D3.1 comment #133

Comment#133

SC 85.8.3.5

Figure 85-5— Transmitter test fixture

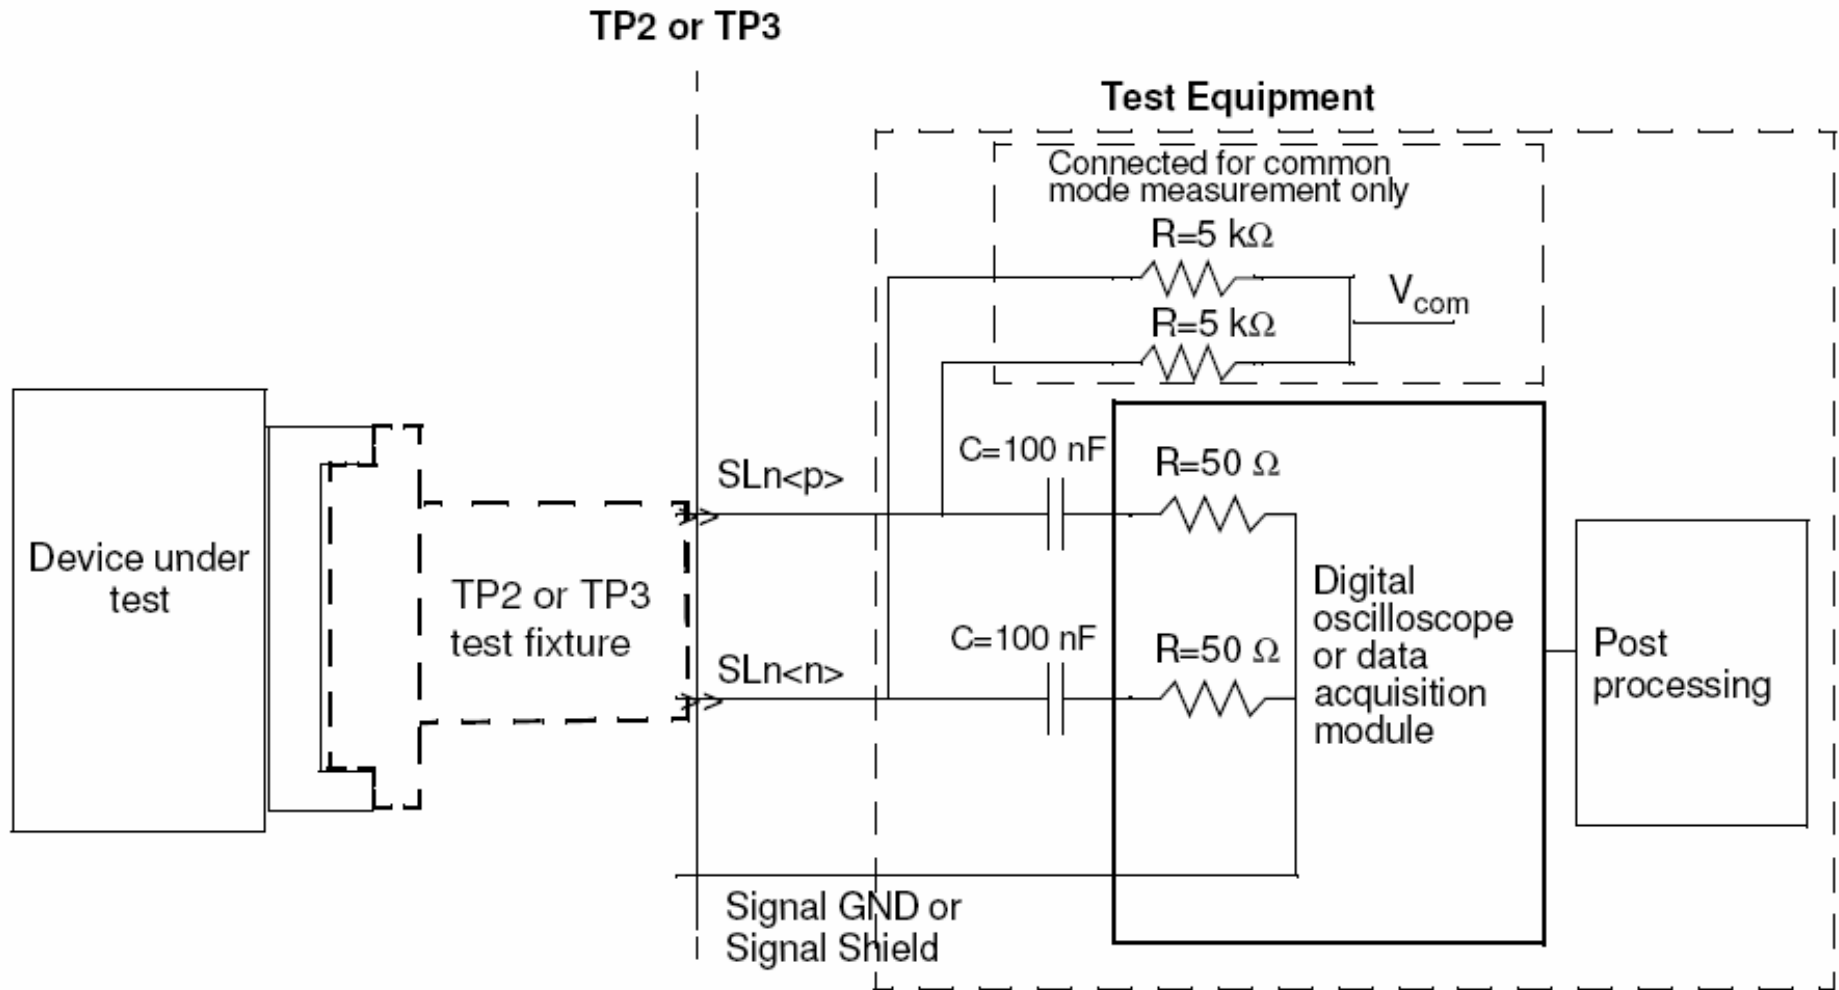
Figure 85-5 is not implemented as was suggested in draft 3.0 comment 831. The DUT is still not drawn in the figure and the dotted DUT box is in the wrong place.

Remove the box labelled DUT around the test fixture. Add a DUT to the left of the figure. Figure 85-14 with the Cable Assembly test fixture relabelled DUT (and the test interface on the left removed shows how the DUT should look.

Figure 85-5 per suggested remedy
